COMMITMENT RESOLUTION LETTER #4
DOCKET NO. 72-22 / TAC NO. L22462
PRIVATE FUEL STORAGE FACILITY
PRIVATE FUEL STORAGE L.L.C.

RAI's 2-5 and 2-7 (first round), Seismic Program

Figure 1
PROPOSED LOCATIONS OF
CONE PENETROMETER TESTS
PRIVATE FUEL STORAGE FACILITY

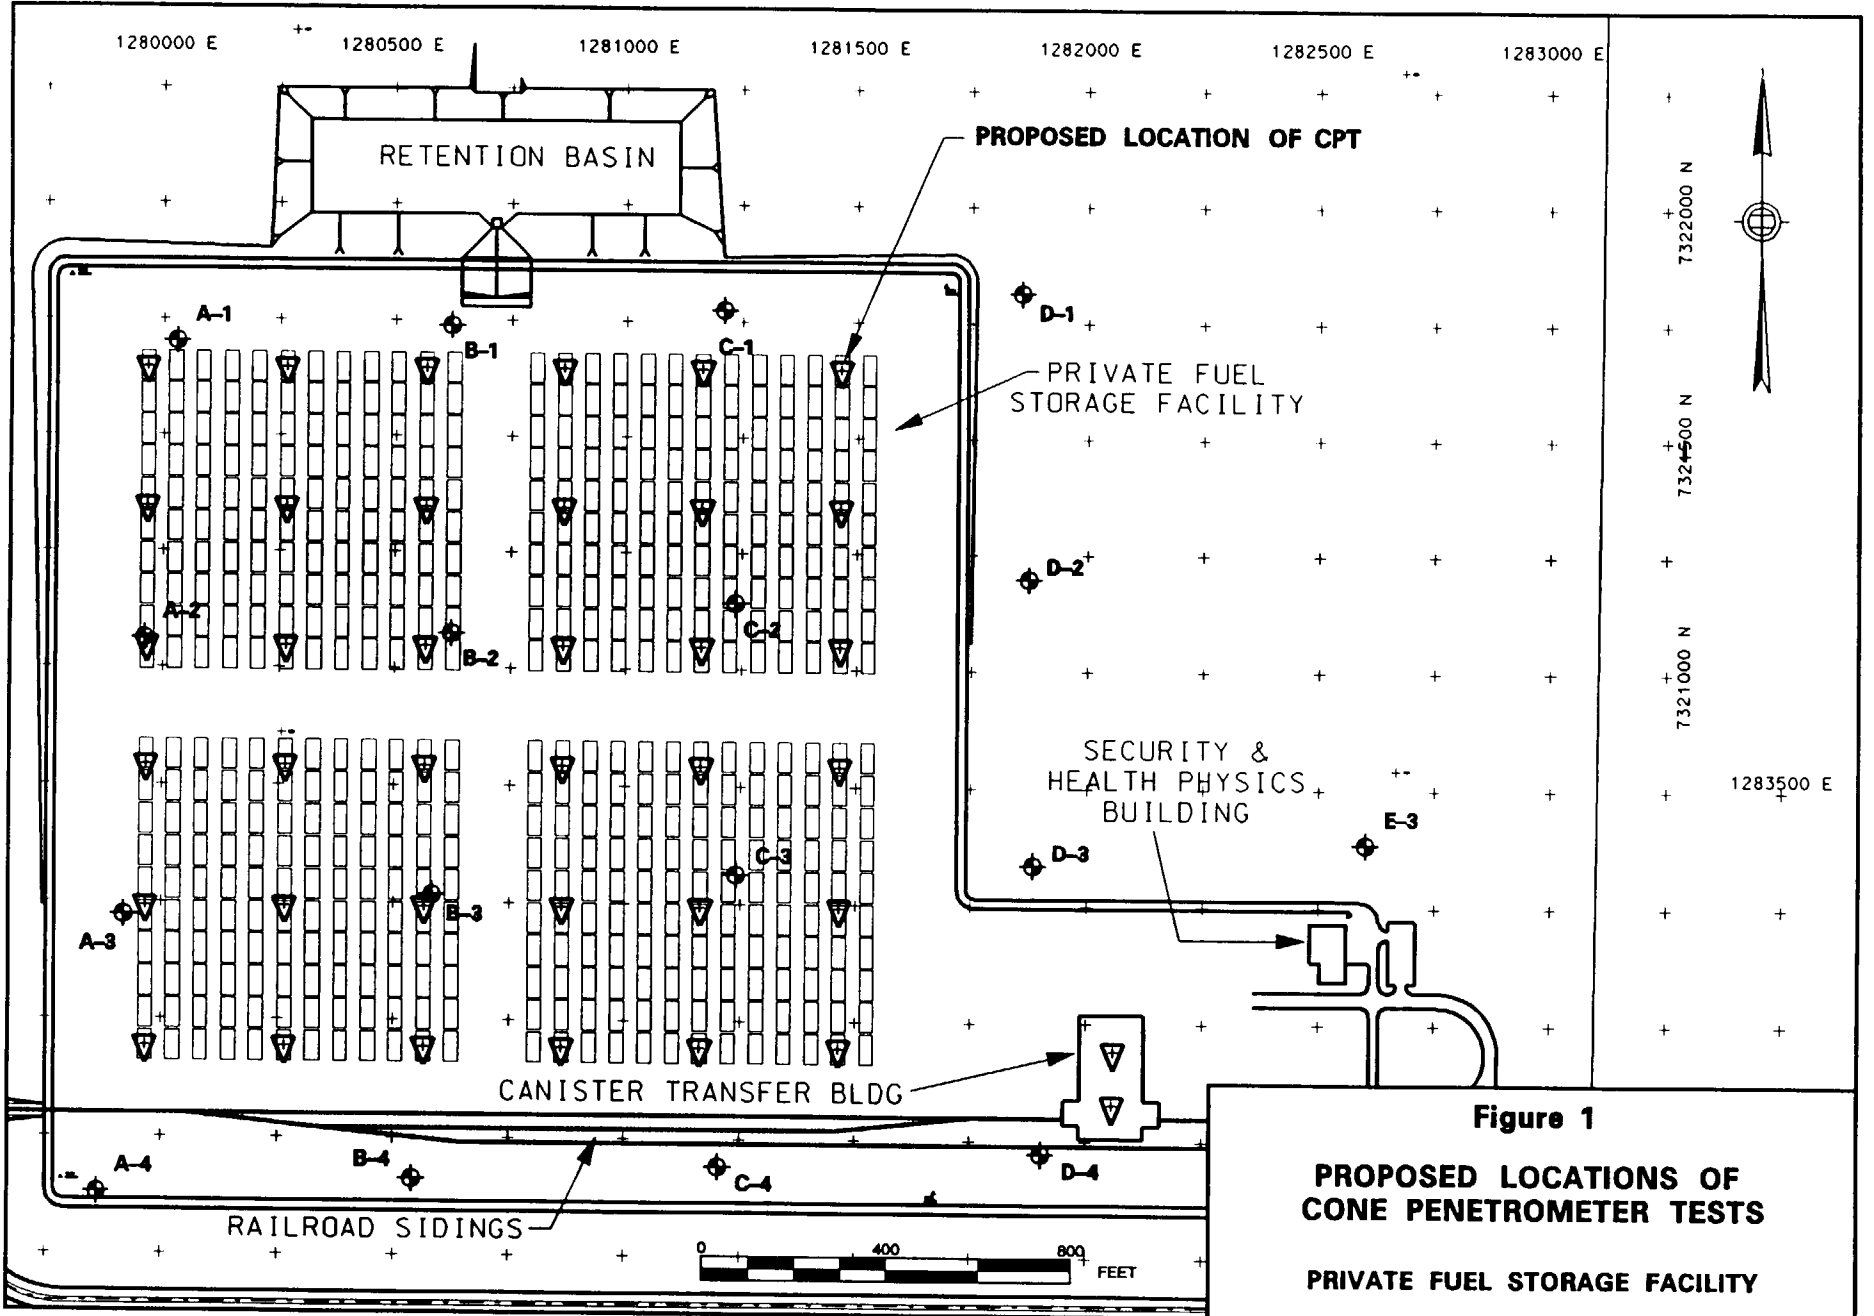
NRC Comment – The PFS field geotechnical investigation program is limited in the number of borings and tests provided and relies heavily on the Standard Penetration Test blow counts (N-values) to extrapolate results of laboratory tests to deeper soils within the profile. PFS should further justify that the subsurface conditions at the site are uniform. PFS should explain how the N-values were used in developing the SAR. In addition, PFS should provide profiles of shear strength and compressibility of the soils within the depth interval of 10 ft to ~25 ft. PFS should consider performing additional field tests to determine in situ shear strengths, such as field vane tests or cone penetrometer tests, to determine the extent and thickness of the lower blow count soils on site.

Phase 1 of this program will include performing 36 CPTs, located on a grid pattern of ~300 ft within the entire emplacement area. This pattern will provide nine CPTs in each of the four quadrants occupied by the cask storage pads shown in the attached Figure 1. Several of these CPTs will be located in close proximity to the locations of the borings that were drilled in the emplacement area to permit using the existing boring information in interpretation of the CPT data. The results of the Phase 1 CPTs will include continuous profiles of sleeve stress and tip resistance, which will be used to identify the extent and thickness of the lower blow count soils within the upper layer. These data will also be interpreted to provide profiles of soil stratigraphy, blow count, and strength.

In Phase 2, the cone penetrometer technology will be used to perform dilatometer tests (DMT) to develop profiles of the compressibility of the in situ soils at the locations identified in Phase 1 where the softer soils exist. These data are expected to provide sufficient information on the strength and compressibility of the in situ soils over the entire emplacement area.
